FED. ROAD DIST. NO.	STATE	FED. AID PROJ. NO.	FISCAL YEAR	SHEET NO.	TOTAL SHEETS
HAWAII	HAW.	BR-STP-056-1(35)	2000	C.O. 17	70

WAIKAEA BRIDGE WIDENING

KUHIO HIGHWAY-WAIKAEA BRIDGE WIDENING
Fed. Aid Proj. No. BR-STP-056-1(35)

PARTIAL PLAN

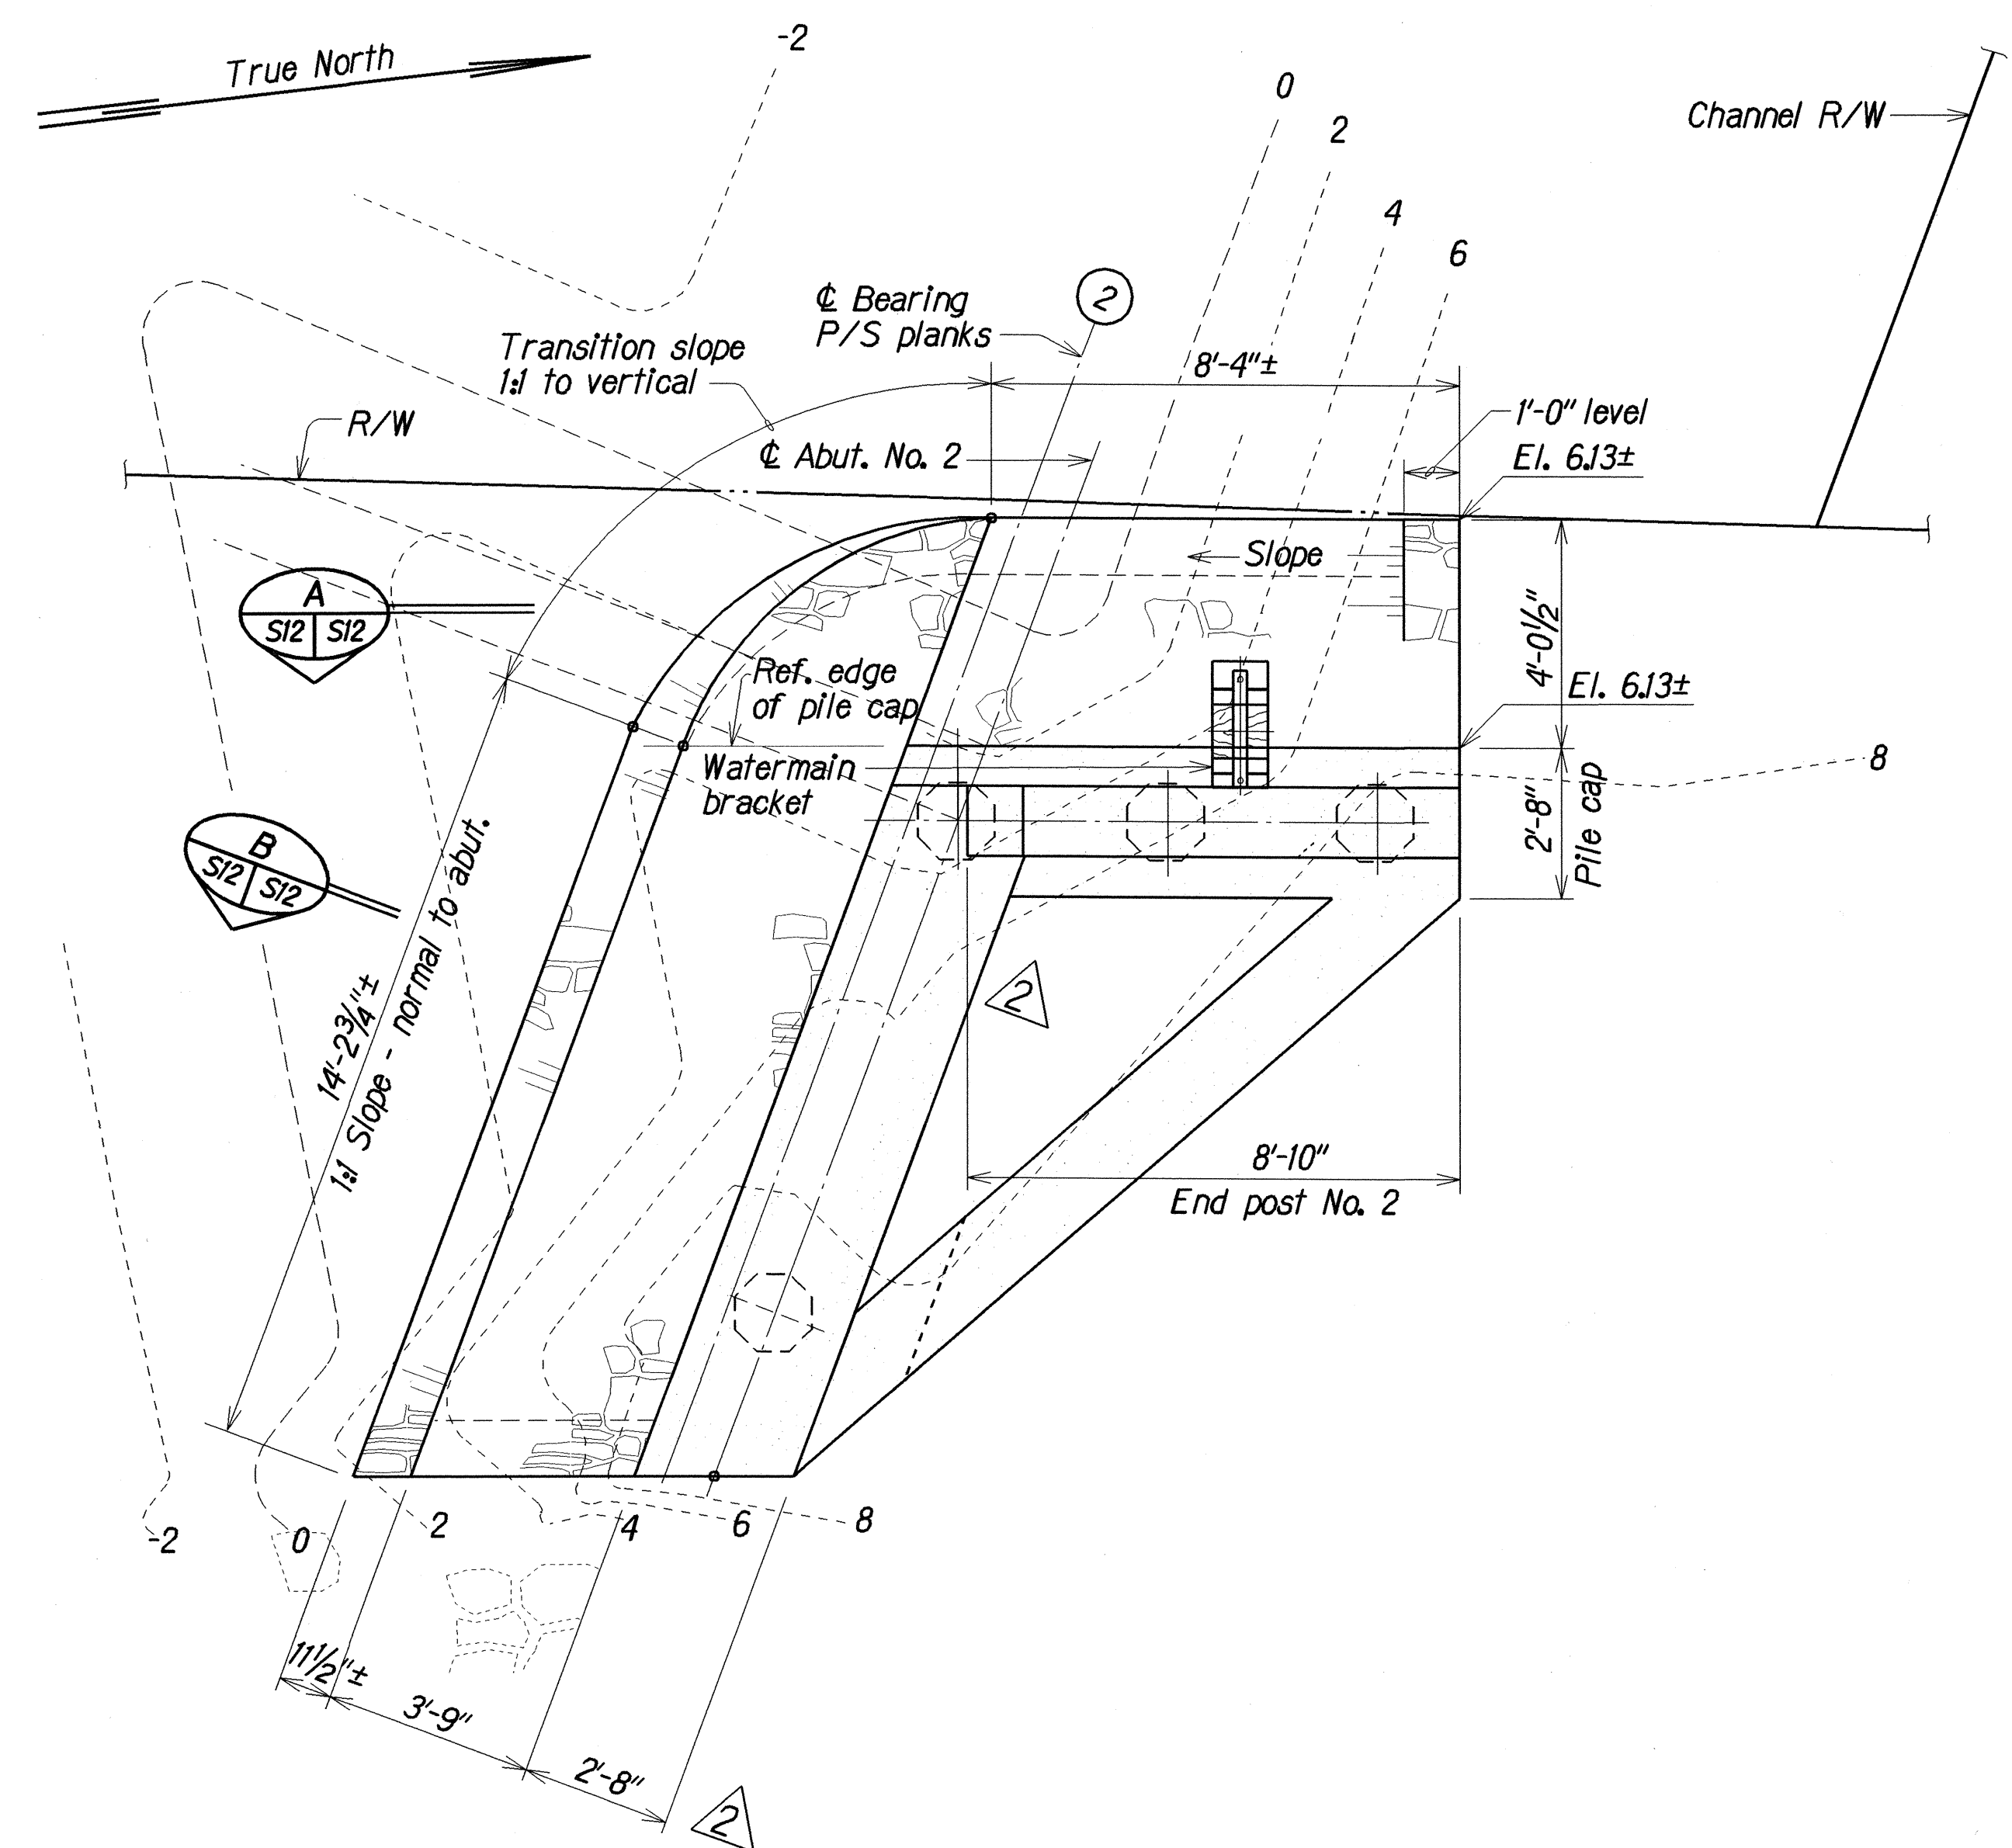
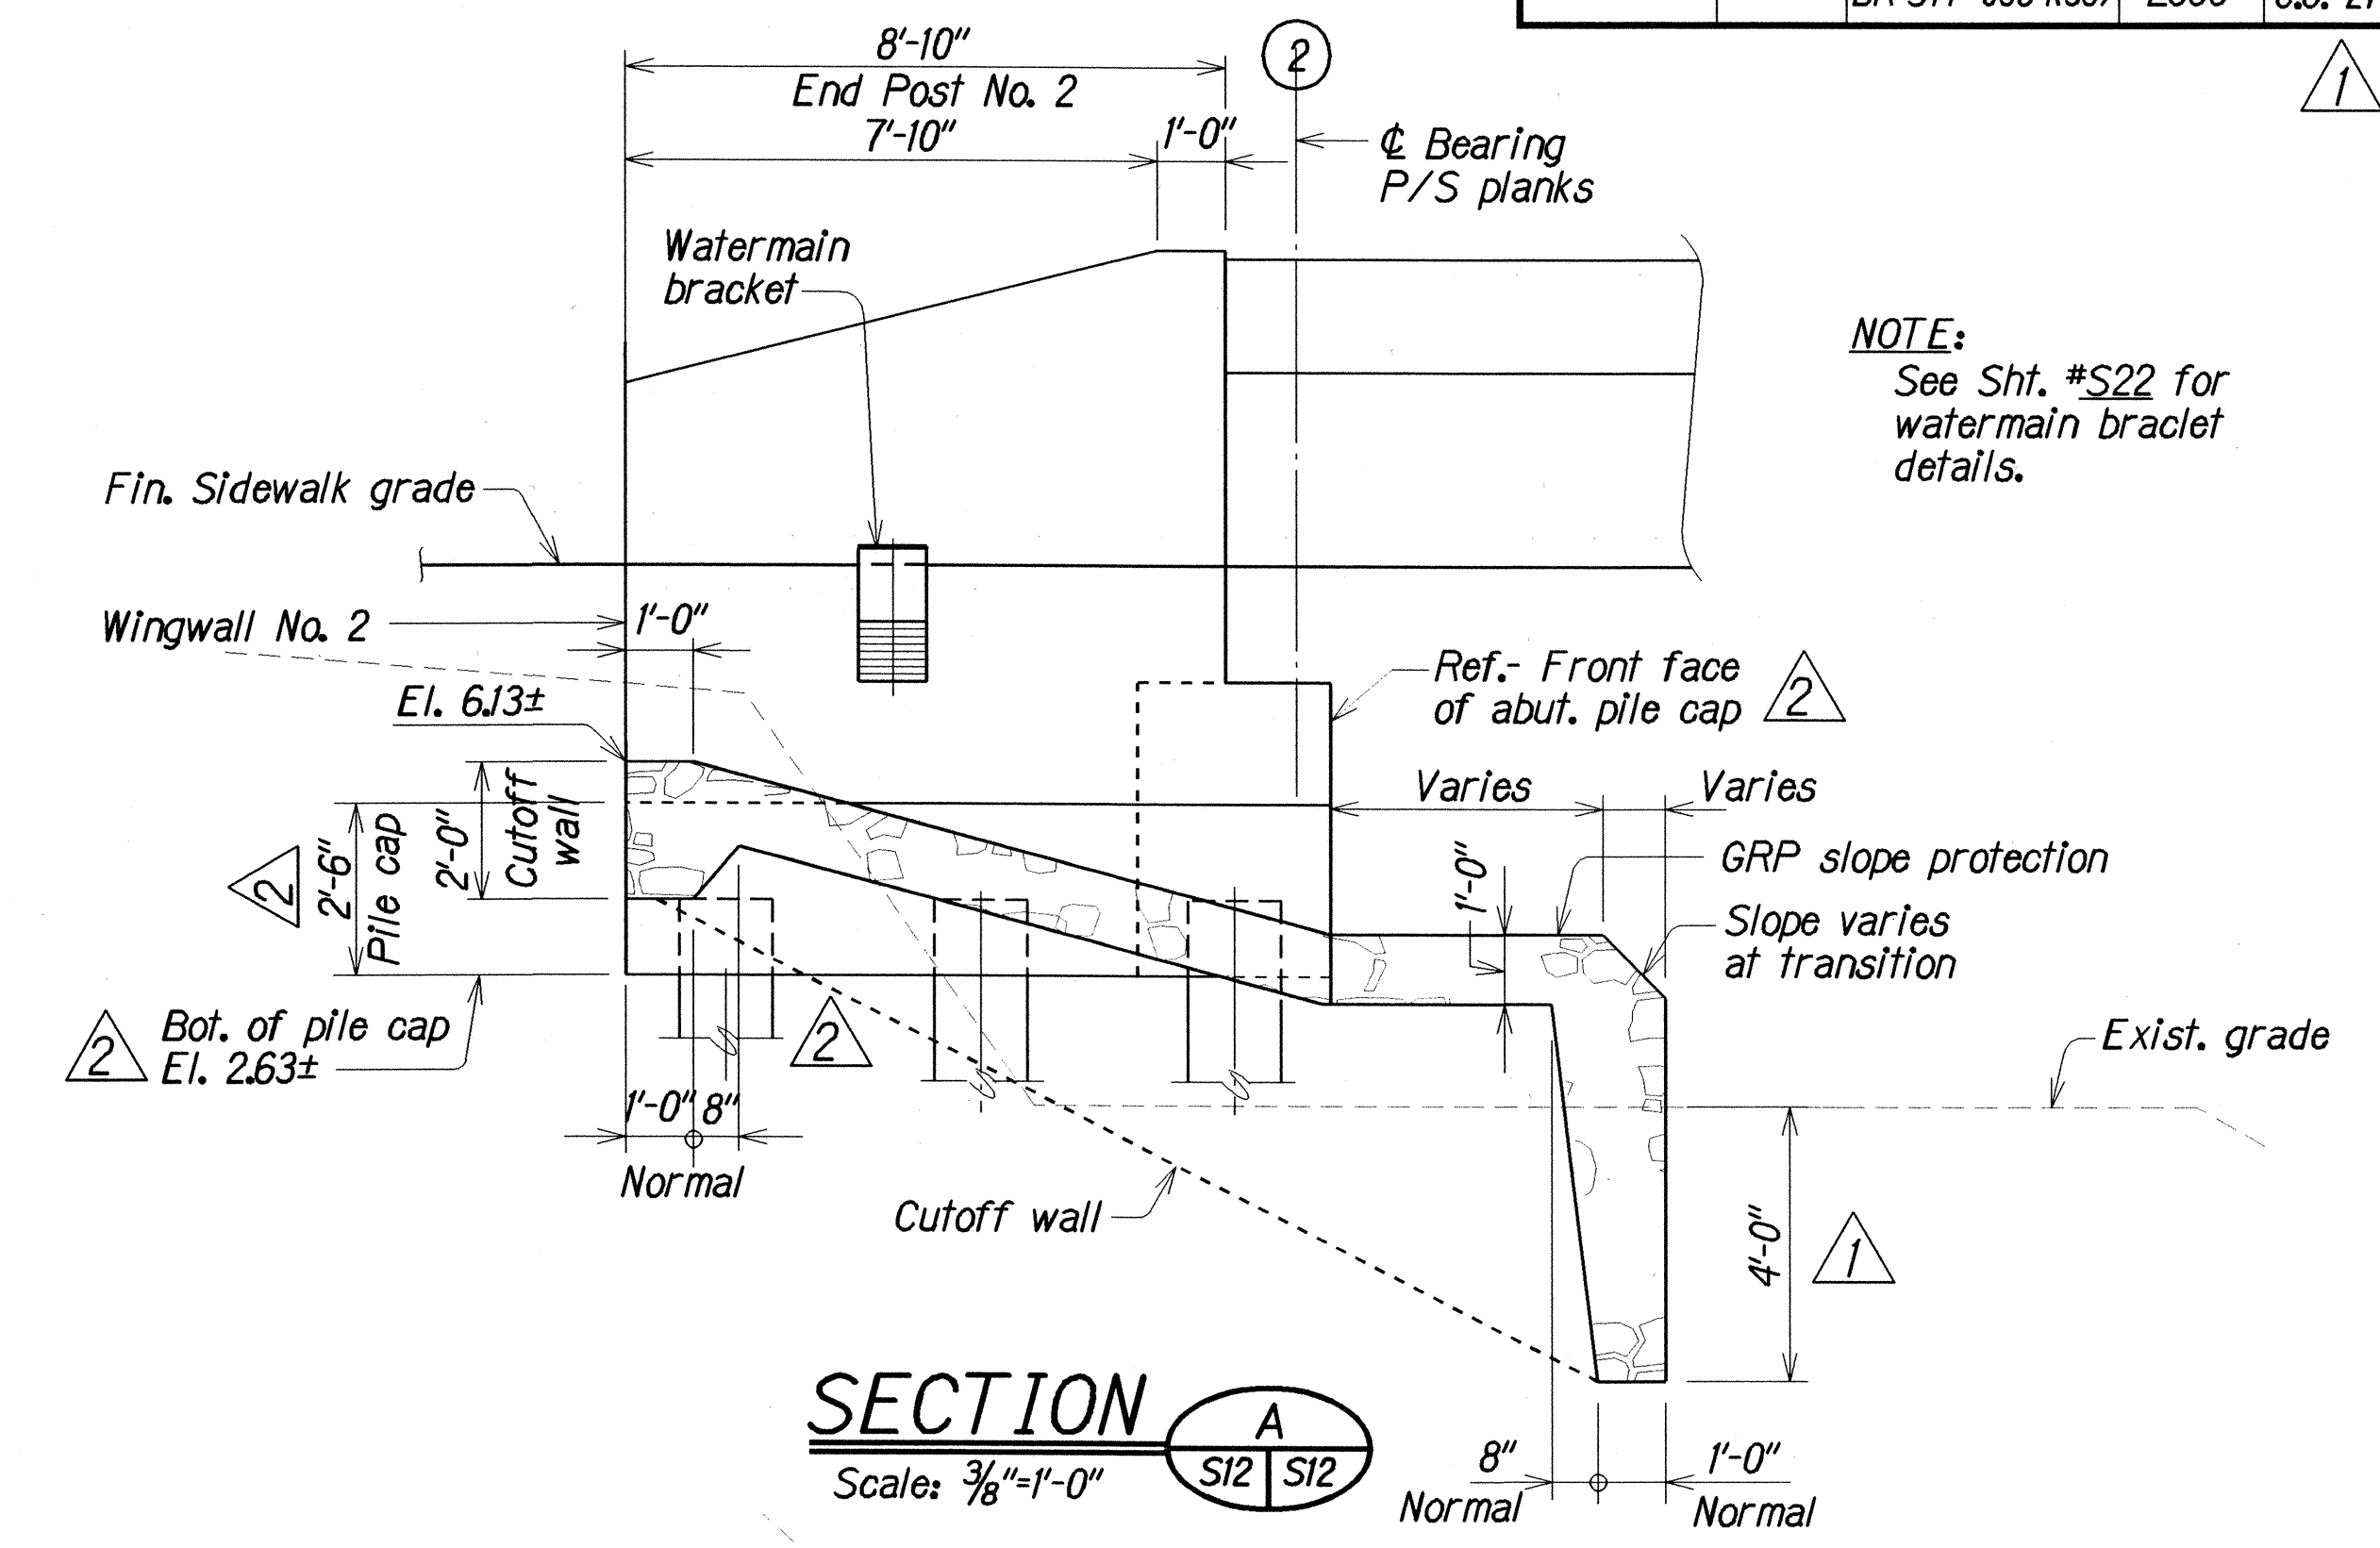
Bot. of abut. pile cap elevation changed. Piles, bridge, wingwall, & abut. pile cap, lowered to accommodate changes. GRP removed behind front face of abut. pile cap. Labels moved and changed for clarity. Label reading "Bot. of fig." at Partial Elev. changed to "Bot. of abut. pile cap". Pile outline relocated to reflect correct location and extended pile cap removed. Note #1 added.

Changed dimension so that 4'-0" is measured from exist. grade to bottom of cutoff wall. Drawing altered and dimension moved to accommodate changes. Sht. no. changed to indicate change order.
